NOTICE OF MEETING
PLANNING AND ZONING COMMISSION
6:00 P.M. – January 14, 2021
30360 Cougar Bend, Bulverde, TX 78163

PLANNING AND ZONING COMMISSION ITEM:
PC-20-02
FINAL PLAT
JOHNSON RANCH NORTH UNIT 9

SUBJECT: Johnson Ranch North Unit 9
Final Plat / Construction Plan Acceptance

SUBDIVISION PLAT BELLE OAKS RANCH, PHASE VI

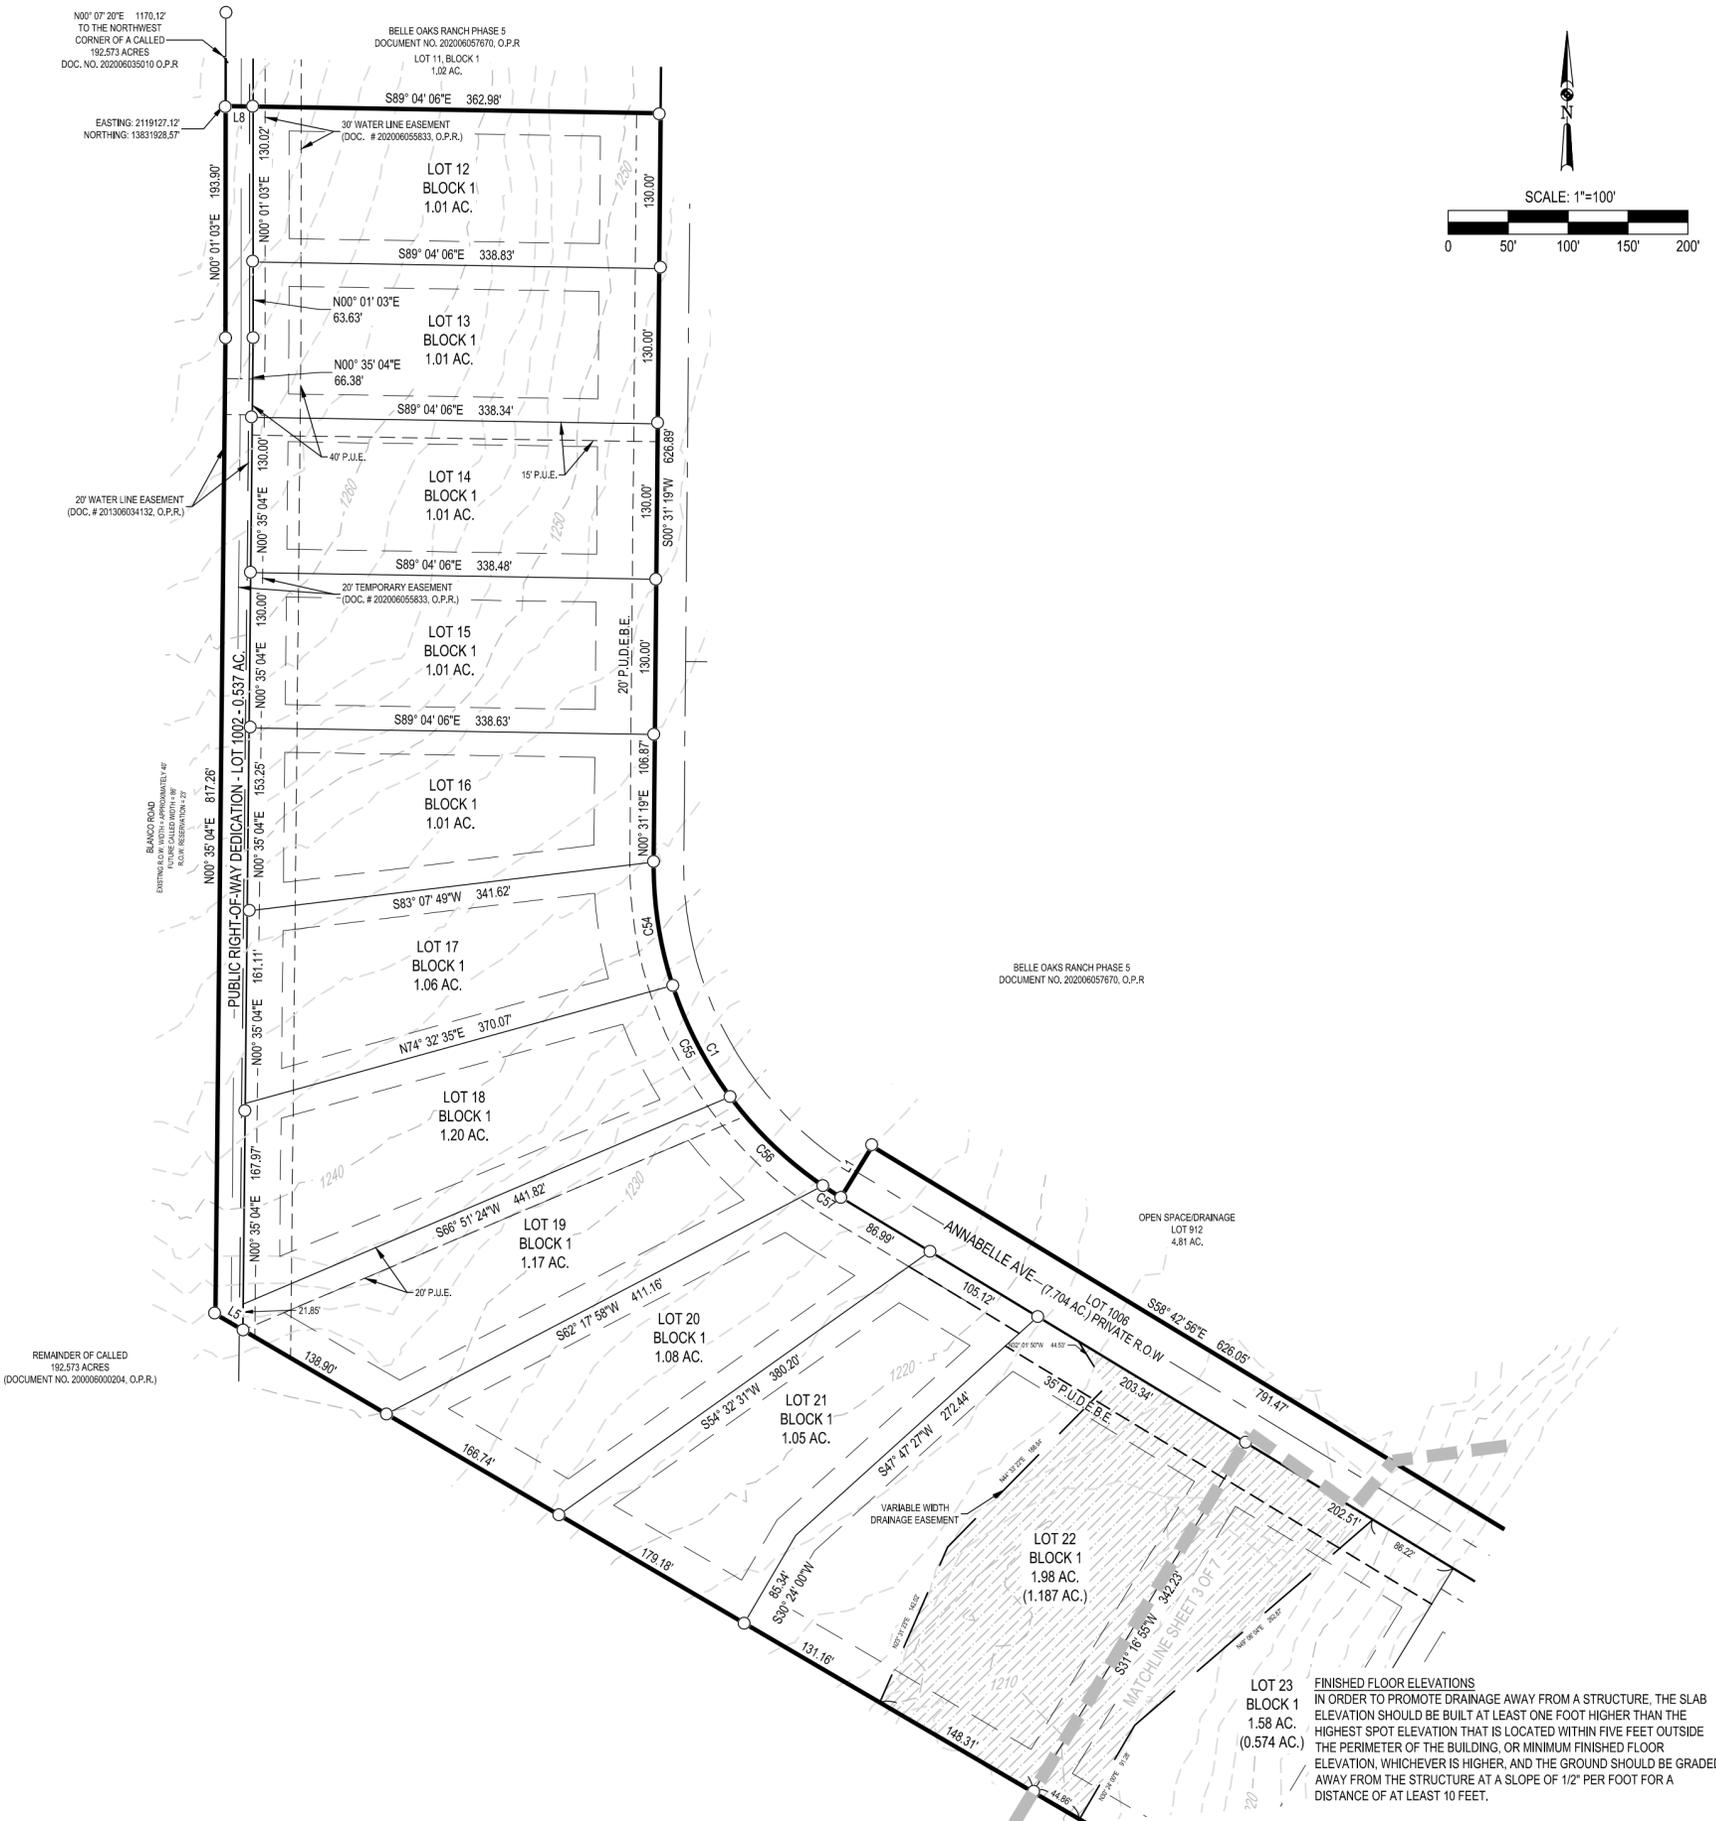
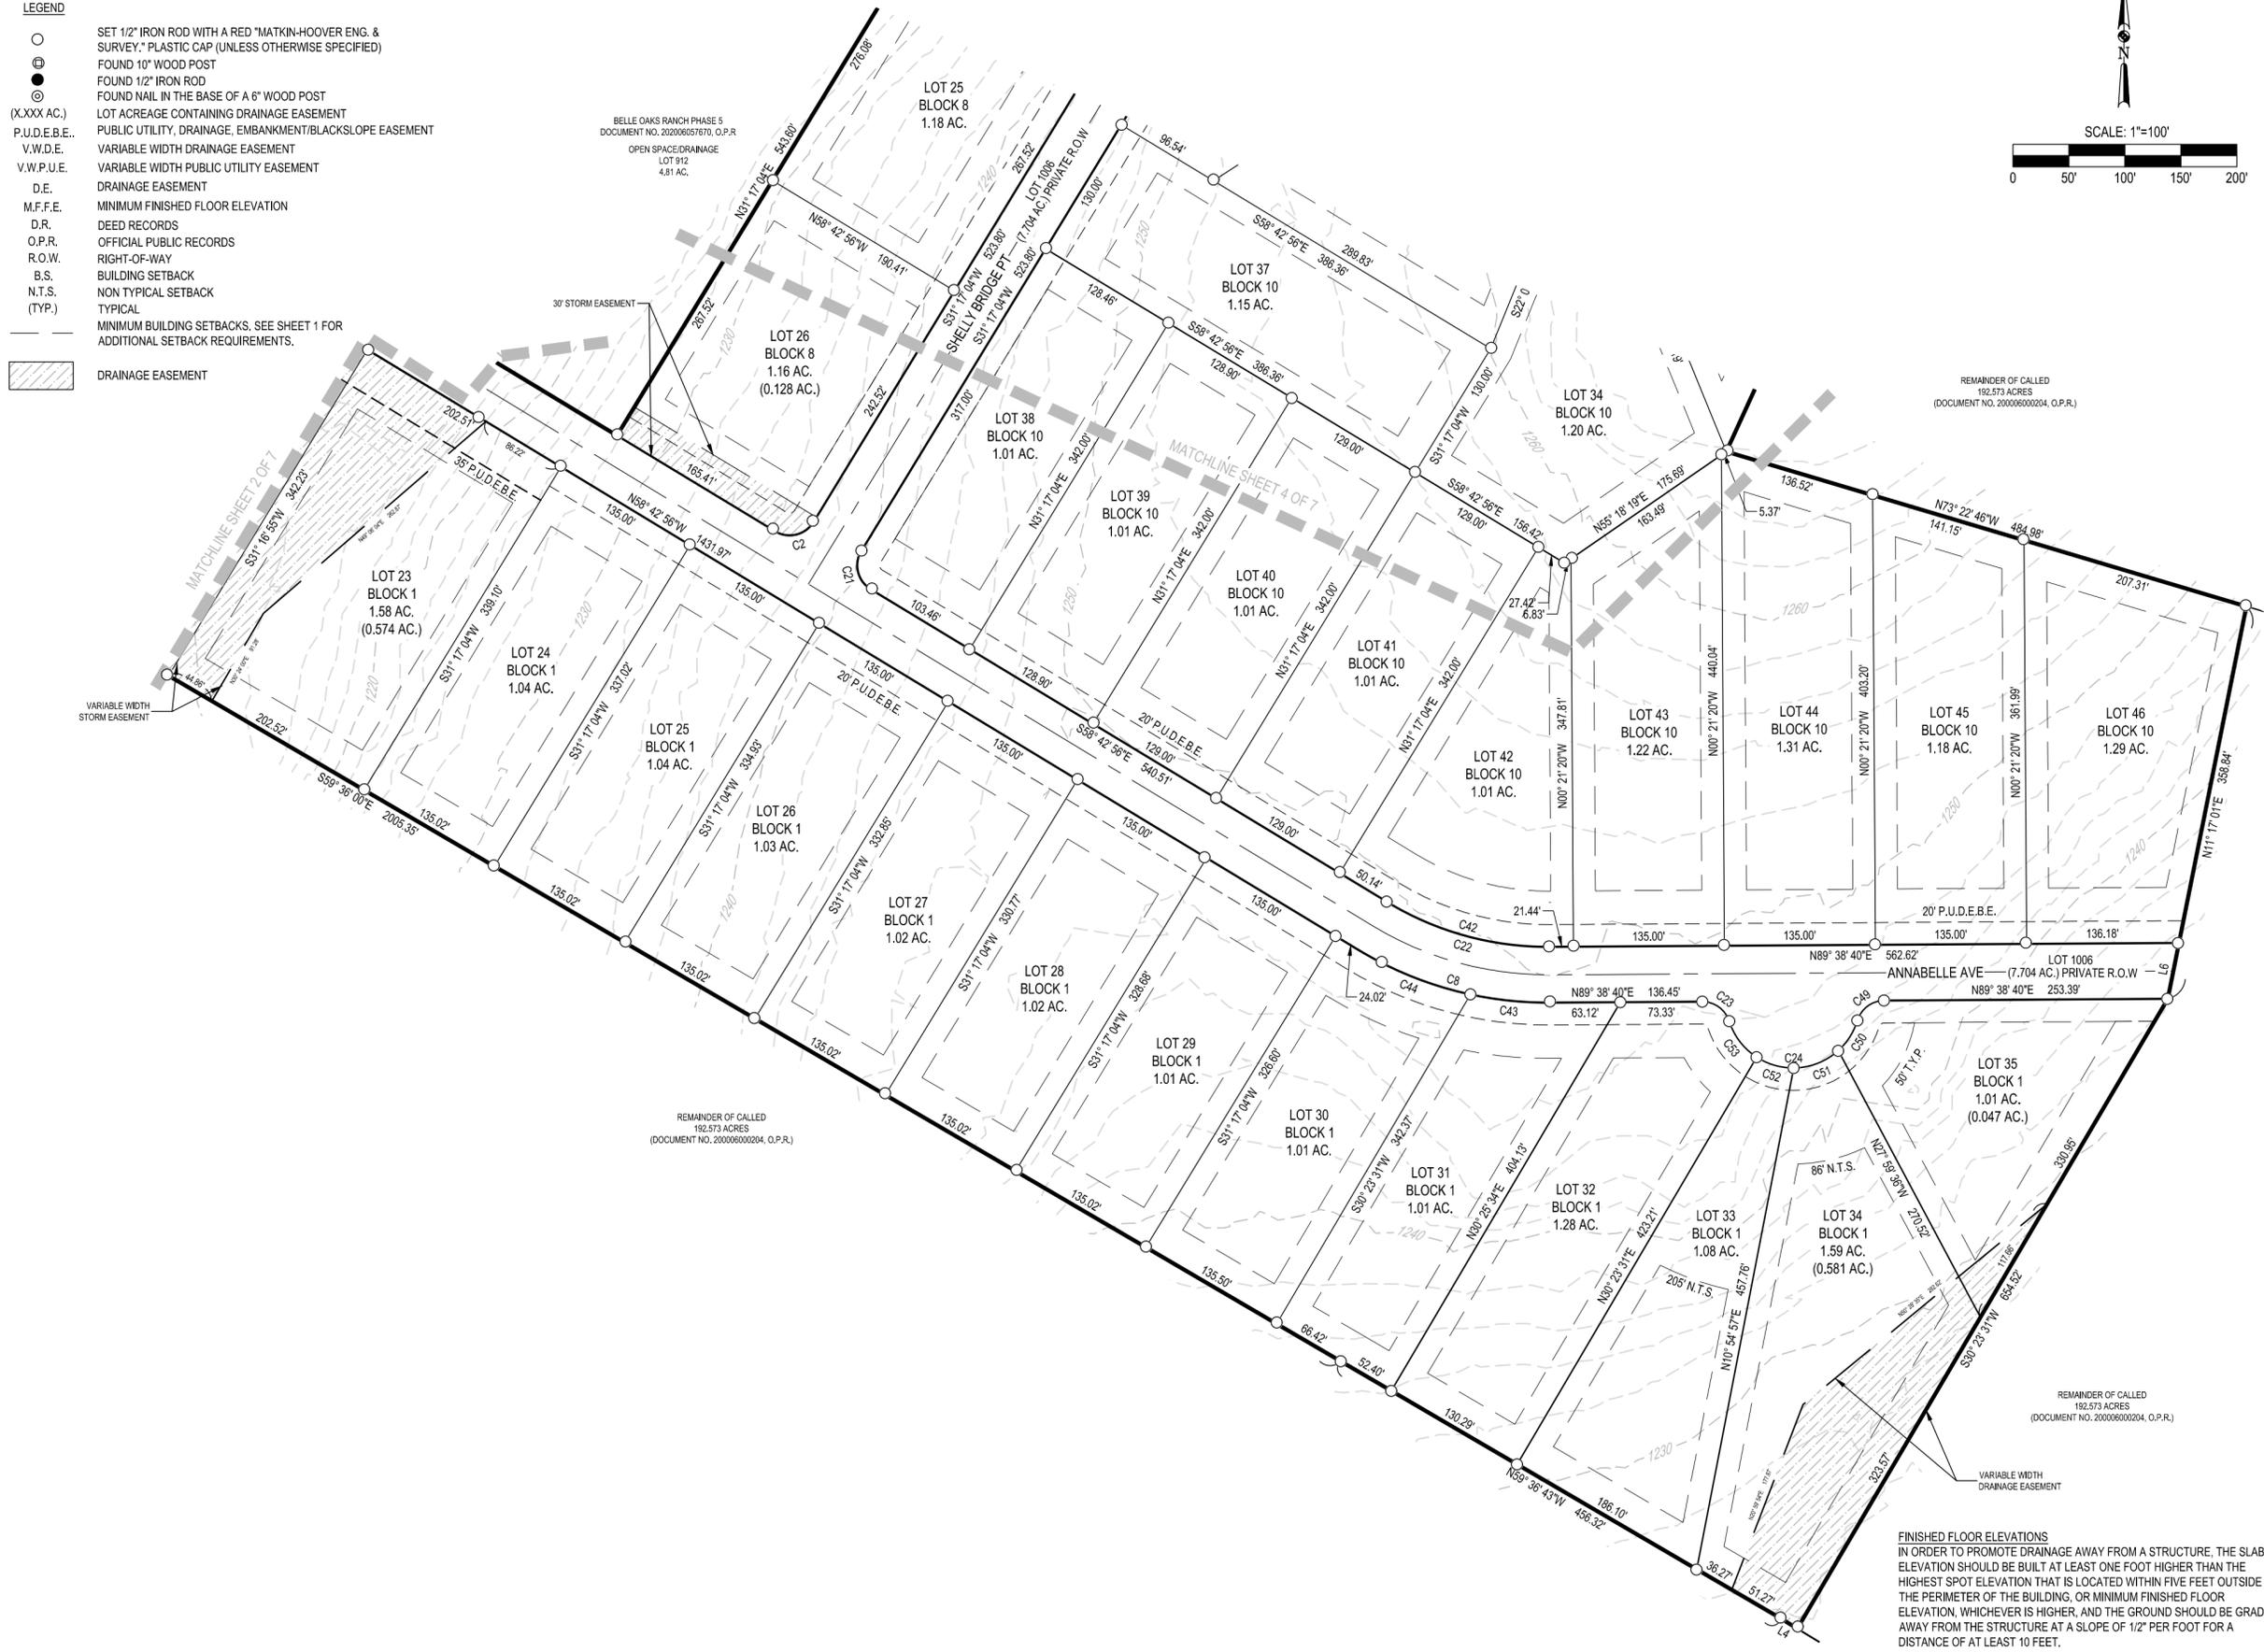
- MDP limits the # of lots for Phase 6 to 74 lots, but plat sheet 1 says “77” lots and 82 were counted. Please revise to max shown on MDP or update MDP. – **Comment resolved...the last approved MDP, dated 10/15/2019, showed 615 total lots for the development. Since then, the Phase 5 & 6 boundaries have been adjusted to address City comments and 4 lots have been moved from Phase 5 to Phase 6, but the total lots have not increased for the development.**

4. FEMA floodplain/drainage easement missing from Lot 34, Block 1. – [Comment resolved](#)

5. Verify that fire hydrant spacing is within requirements. There are multiple areas that seem to have more than 500' of street distance between hydrants (as measured along the water line/easement). – [Comment resolved](#)

6. The following lots do not appear to meet minimum frontage requirements (105 feet):
 - a. Lot 17, Block 1 – [Comment resolved](#)
 - b. Lot 18, Block 1 – [Comment resolved](#)
 - c. Lot 19, Block 1 – [Comment resolved](#)

7. The following lots do not appear to meet the maximum aspect ratio requirements (4 to 1):
 - a. Lot 34, Block 1 – [Comment resolved](#)
